PINEHURST APARTMENTS

12303 15TH AVENUE NE, SEATTLE
DPD Project #3022681

Recommendation Meeting
Northeast Design Review Board
August 28th, 2017

EDG RESPONSE

BIRDSEYE VIEW OF NORTH AREA FACING BUILDING

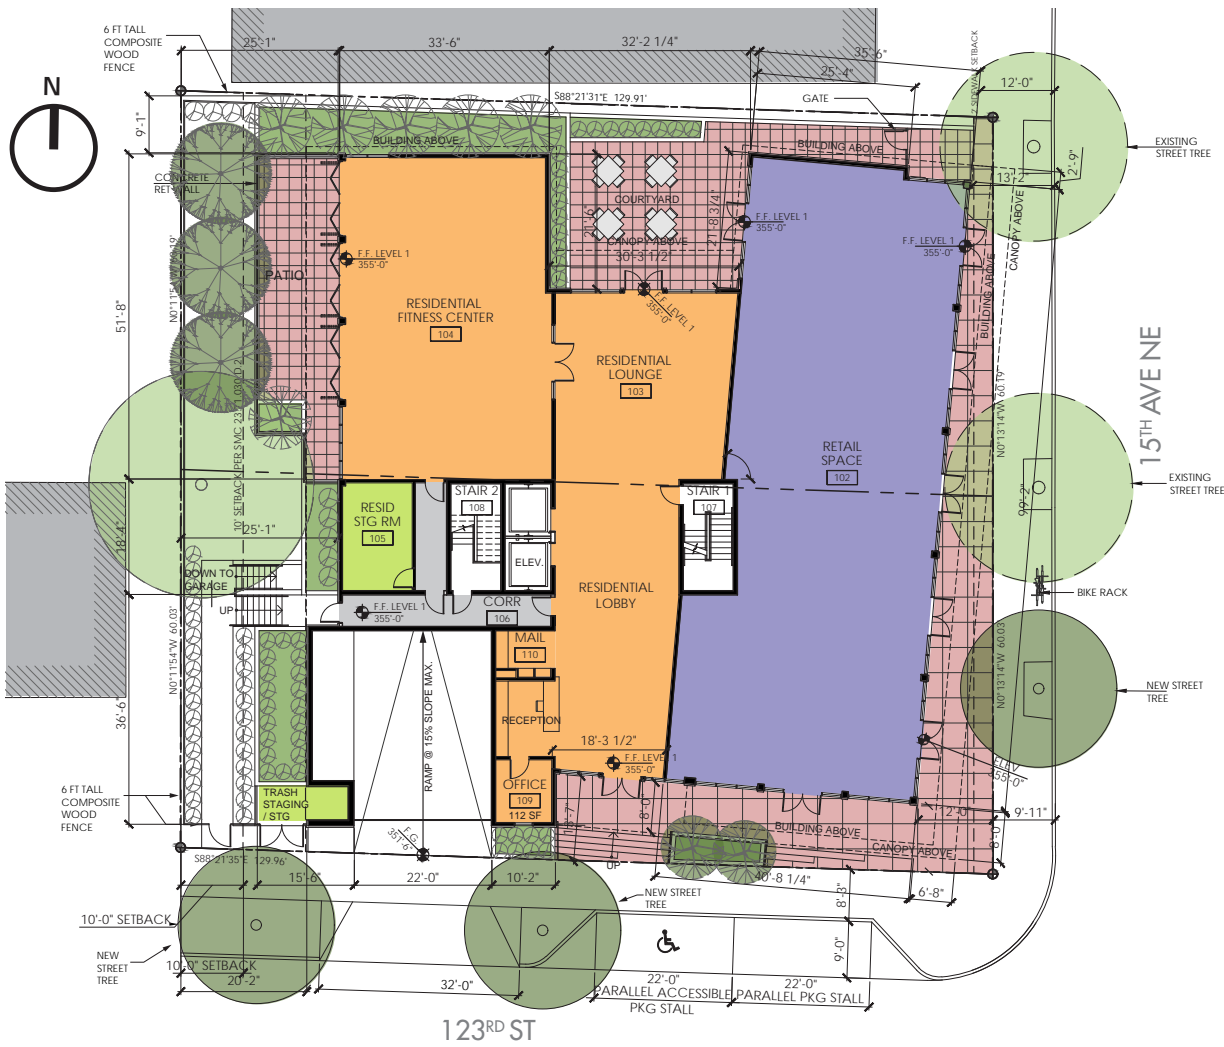
2. HEIGHT/BULK/SCALE

The Board supported the general approach to the preferred massing concept but wanted more information about this concept in terms of exterior outdoor spaces, the location of fences, and proximity to the adjacent apartment building located to the north. Members were concerned about potential impacts to the adjacent apartment complex in terms of balcony placement and views, and suggested that the applicant conduct additional research and outreach with adjacent neighbors. The Board also entertained the idea of truncating the building and pulling it back away from the adjacent apartment to the south as means of reducing potential visual impacts. The Board requested that additional information on the ‘closeness’ to the adjacent apartment, balcony placement and suggested that sections be developed and provided at the next meeting too. (CS2-B, CS2-D, DC2-E, DC4-D)

RESPONSE: Exterior outdoor spaces are provided for spill-out and seating for the retail spaces along both 15th Avenue and 123rd Street. An enlarged seating area and gathering space is provided at the street corner as well. Outdoor seating and gathering is provided at the building entrance for the tenants along 123rd Street. An outdoor patio space is designed as a spill-out area for the fitness room and can also be used for fitness activities. A ground floor courtyard space can be accessed from 15th Avenue and is provided in the middle of the building and will be a private area. The second floor has a roof deck that will include BBQ areas and seating for the residents.

Fences are provided along 123rd Street in the SW corner and run the entire length of the west property line to give privacy to the single family residence. The fence turns along the north property line and terminates at the raised planter bed. The planter bed then acts as the fence or buffer along the north property line, but is less private and is a softer buffer in this location due to the similar use of the adjacent property.

The design has been enhanced on the north property line to help mitigate the distance from the neighboring development. All of the proposed balconies along this façade have been eliminated and moved to other facades. Additionally the windows have been made much smaller on this façade for privacy for each development. Landscaping has also been added between the buildings to create more of a buffer.

SITE PLAN

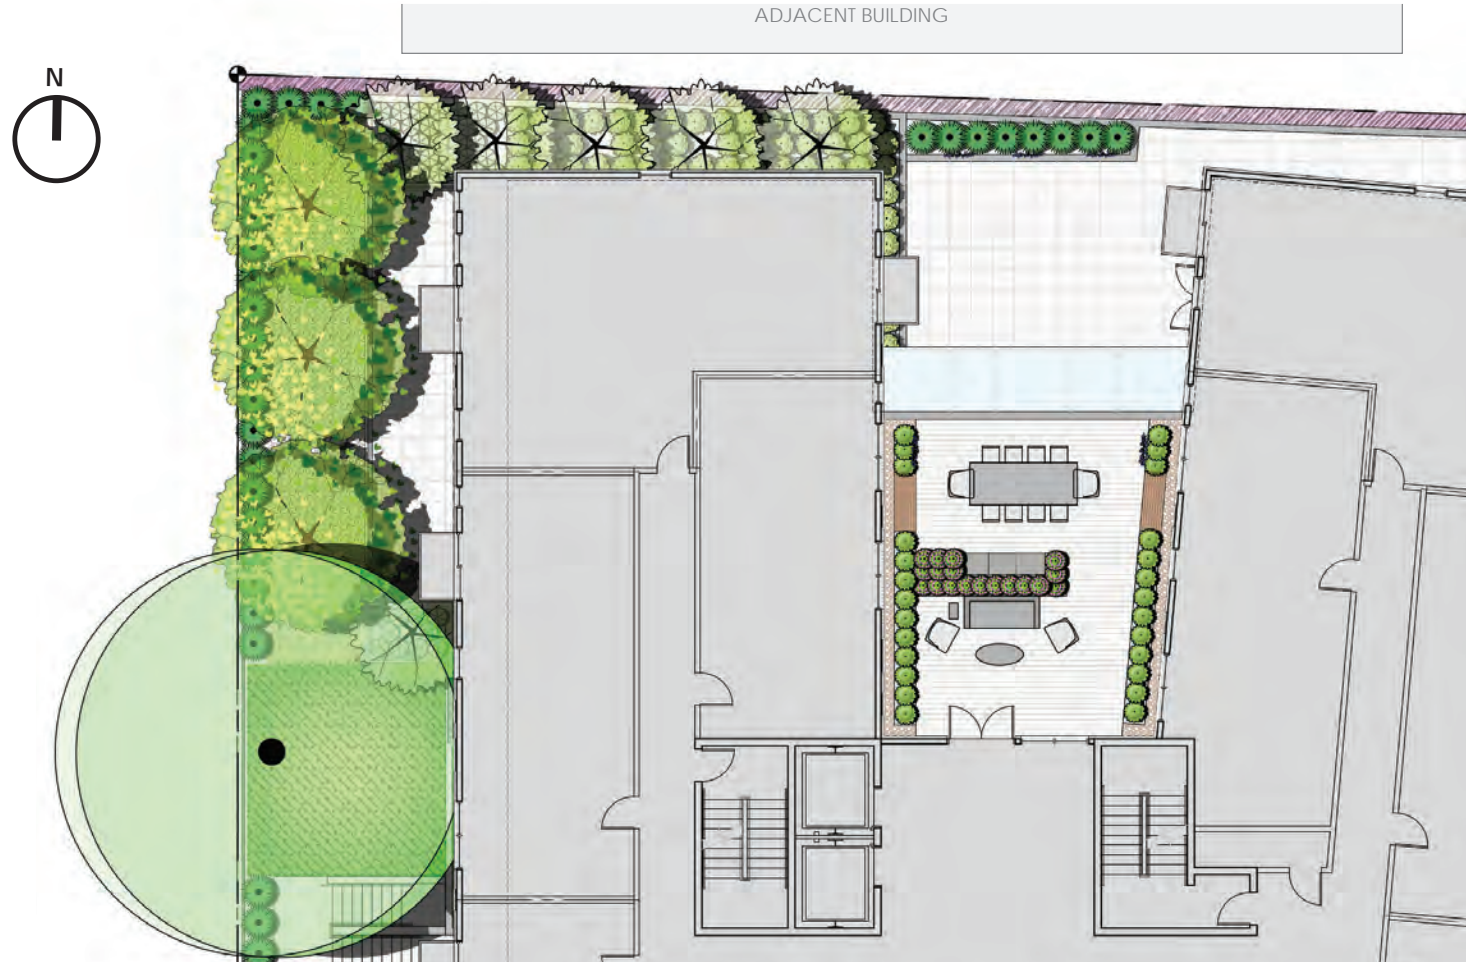
3. RETAIL

The Board liked the horizontal orientation of the first floor commercial space along 15th Ave NE and how it wrapped around the corner and continued along 123rd St. in the Concept 3, the preferred alternative. The Board suggested, however, that the façade along 123rd needs to be better articulated. The Board had questions about the stairwell that splits the two retail spaces and suggested that the stairs be reconfigured to aid in defining the interior courtyard space better and demonstrate how the interior uses may spill out into the exterior courtyard area. Members also wanted to see the inclusion of one additional street tree along 123rd St. (PL2-B, PL3-A, PL3-C, DC4-A, DC4-D)

RESPONSE: The façade along 123rd Street has been further developed and articulated to enhance the pedestrian experience along the street front. The building has been pulled back at the street corner to provide additional seating and gathering areas and has been angled to provide a wider plaza space along 123rd Street. Steps and landscaping are designed along this street as well to articulate and break up the streetfront and create smaller spaces for the pedestrians and tenants as well. Fencing and gates have been added along the SW corner for privacy along the street.

The stairs have been relocated to open up the retail space and allow for more flexibility. This also helps define the courtyard space in the building so that it can be used by the tenant and retail development.

One street tree has been added per the Board’s recommendation along 15th Avenue.

COURTYARD AREA BIRSEYE PERSPECTIVE

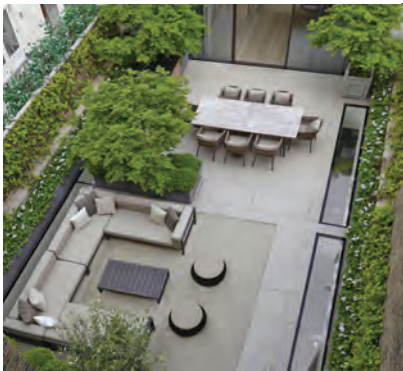
4. ACCESS AND AMENITIES

The Board suggested that there needs to be further exploration of exterior outdoor spaces, landscaping, and fence details; especially in terms of the appearance, and the inclusion of design elements that promote safety. Members suggested that the current landscaping scheme was a bit disingenuous and the exterior courtyard spaces need to be further defined in terms of how the interior uses engage with the exterior spaces. The Board felt that the landscaping scheme depicted on page 24 of the June 27th EDG packet did not show enough information and more detail was needed. The Board wanted to see a diagram which depicts the exterior courtyard concept and that the materials need to be well composed as depicted in some of the character images on page 31 of the EDG packet. (PL3-A, PL2-D, PL3-C)

RESPONSE: Exterior outdoor spaces are provided for spill-out and seating for the retail spaces along both 15th Avenue and 123rd Street. An enlarged seating area and gathering space is provided at the street corner as well. Outdoor seating and gathering is provided at the building entrance for the tenants along 123rd Street. An outdoor patio space is designed as a spill-out area for the fitness room and can also be used for fitness activities. A ground floor courtyard space can be accessed from 15th Avenue and is provided in the middle of the building and will be a private area. The second floor has a roof deck that will include BBQ areas and seating for the residents.

The landscaping design has been further developed and designed per the Board’s recommendation. Trees, planters and courtyards designs have been added to complement the interior areas of the building to make for better continuity between the interior and exterior.

Fences are provided along 123rd Street in the SW corner and run the entire length of the west property line to give privacy to the single family residence. The fence turns along the north property line and terminates at the raised planter bed. The planter bed then acts as the fence or buffer along the north property line, but is less private and is a softer buffer in this location due to the similar use of the adjacent property. A gate has also been added to secure the exterior patio space at the ground level courtyard.

Safety concerns have been addressed with the development of the fences and landscaping planters along the property lines.

FRONT VIEW FROM 123RD ST

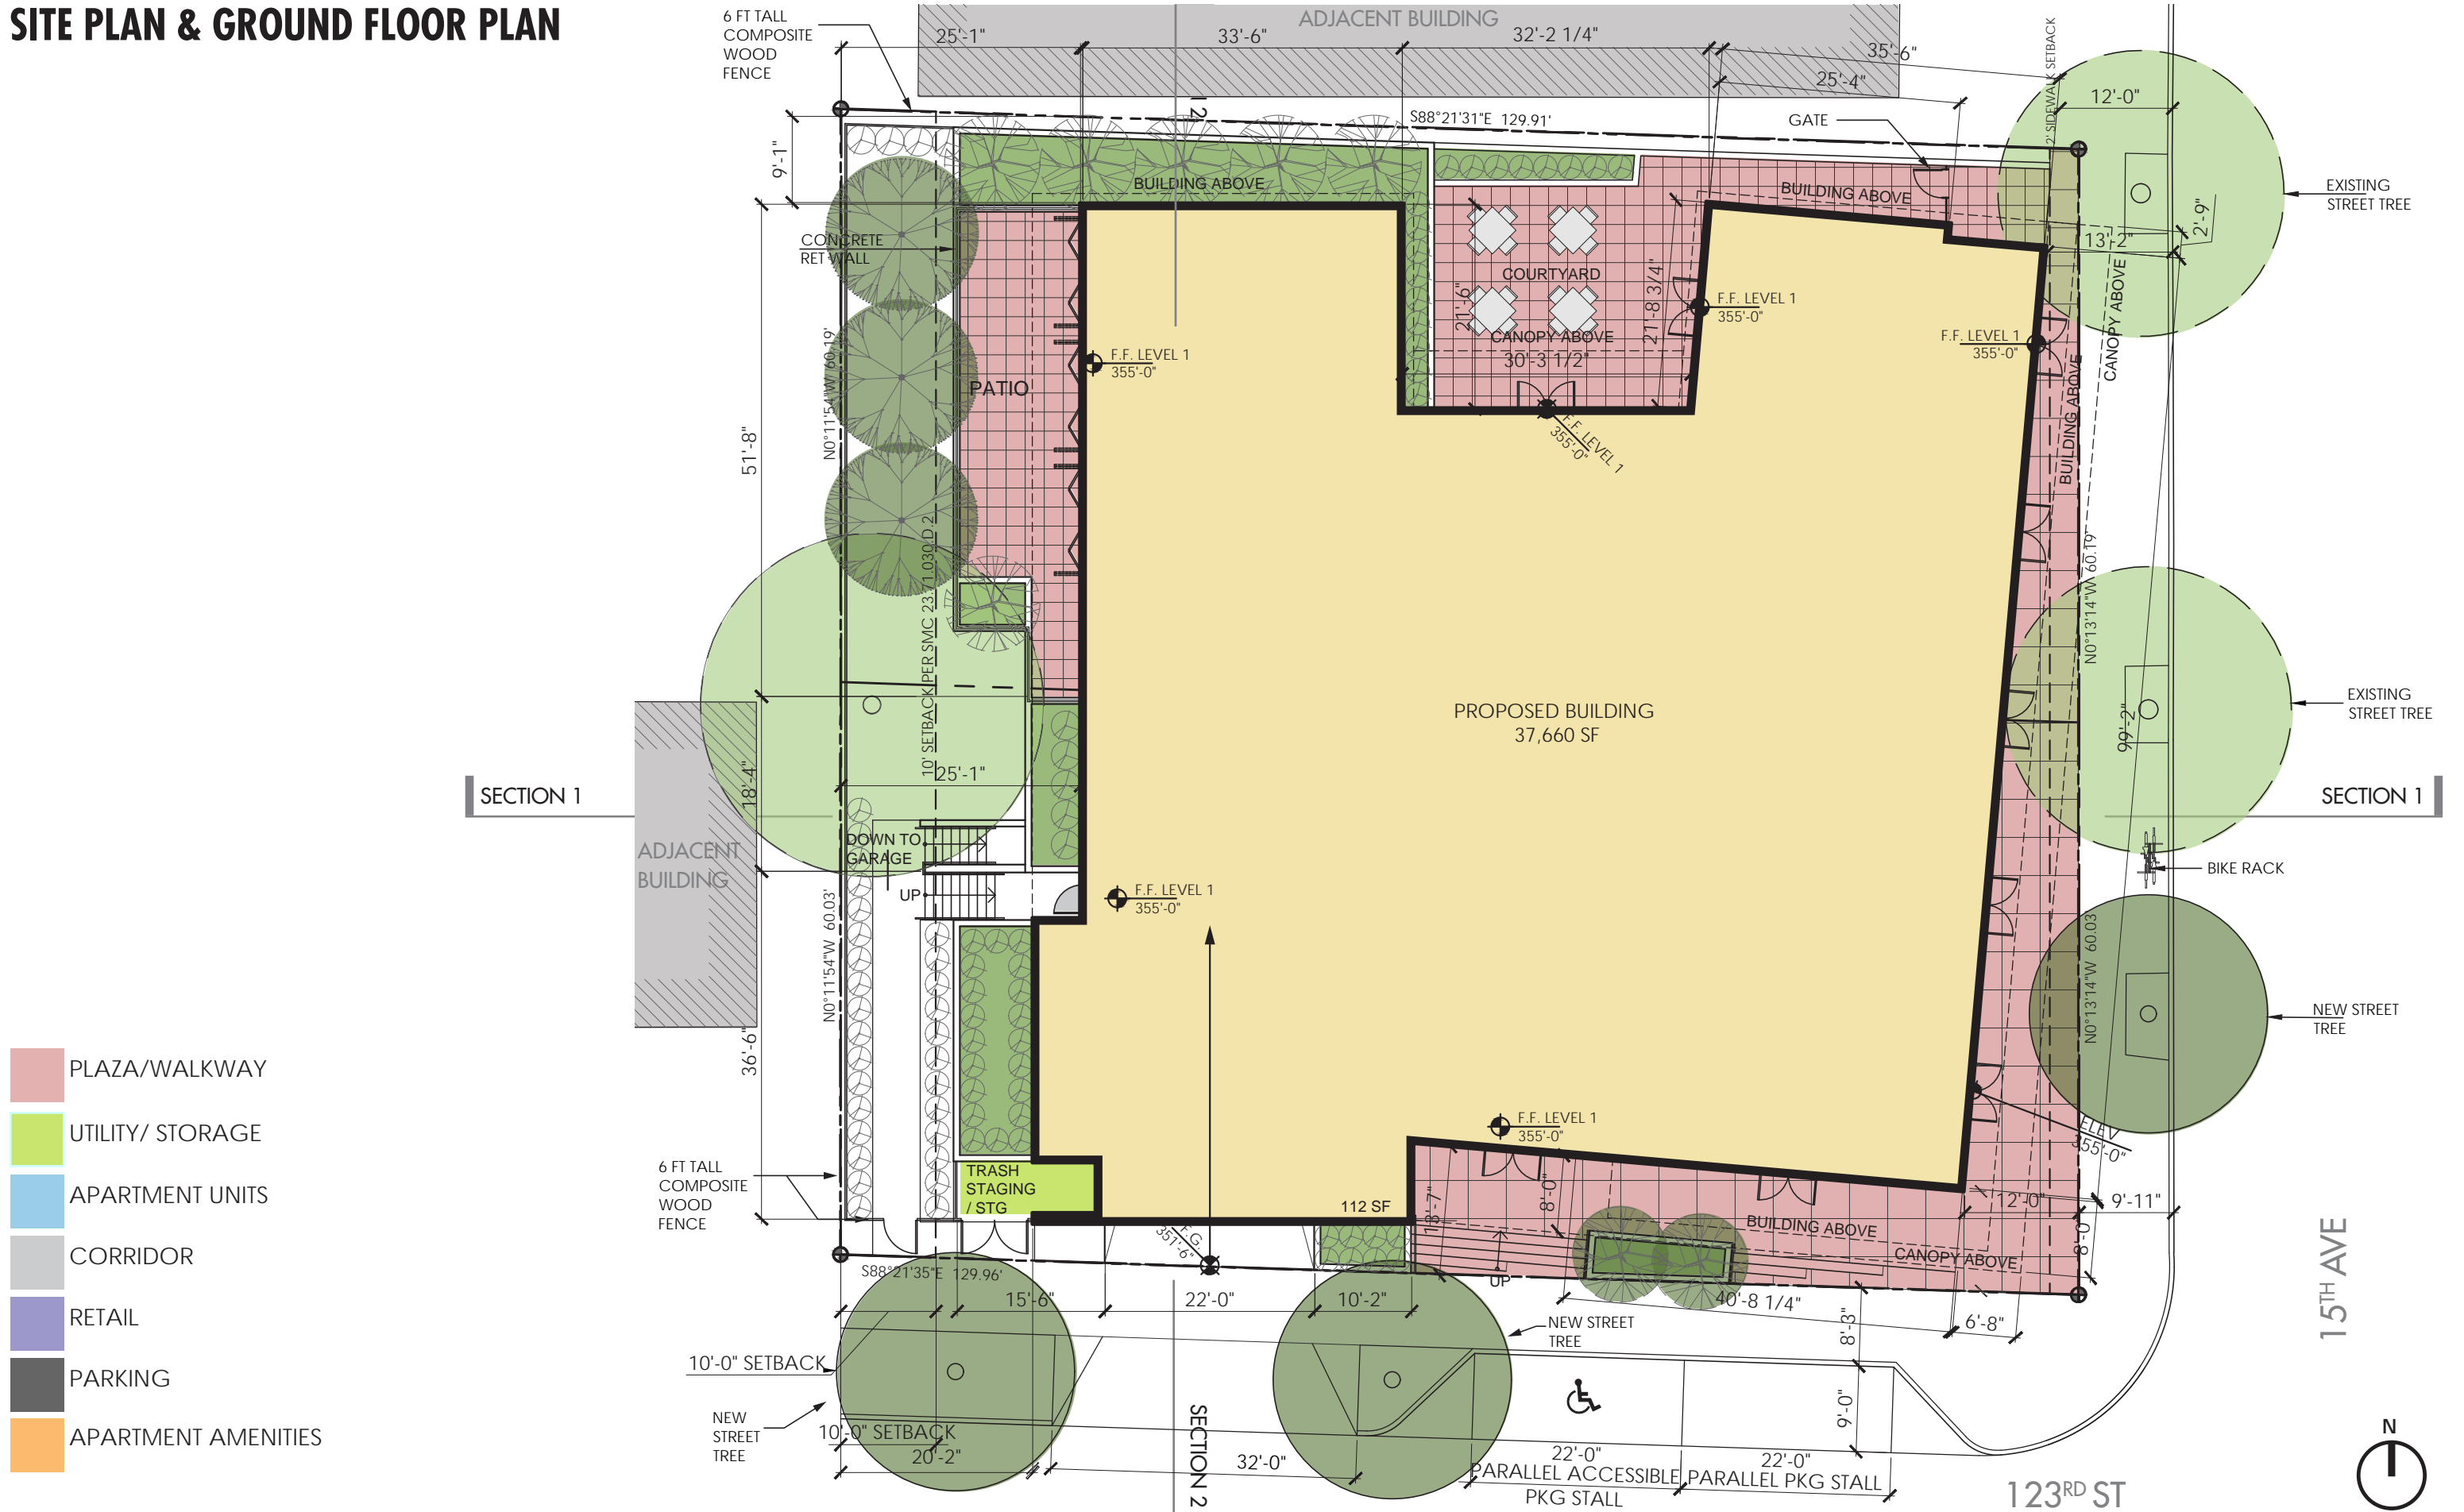
5. EXTERIOR FINISH

The Board was generally in support of the proposed transparency and placement of the ground floor retail spaces and suggested that the rest of the exterior finishes should articulate a simple and clean exterior similar to the character images on page 31 of the June 27th EDG packet and should not be over modulated. (PL3-C, DC2-E, DC4-A)

RESPONSE: The design has been further developed and is now a simple but defined color and material palette that derives from the original concept of keeping a transparent ground floor retail area and a well-defined mass for the residential area. The color scheme is subtle with pops of bright color and material variety that help to define and accent some of the modulation strategies without harming the overall look of the building as a whole. The massing is very clean and simple, while the windows are placed to create a playful pattern and the balconies add details and modulation. The building entrance is designed with an accent color as a point of welcoming and way-finding for the tenants. Openings add another layer to enrich the material and color palette of the building.
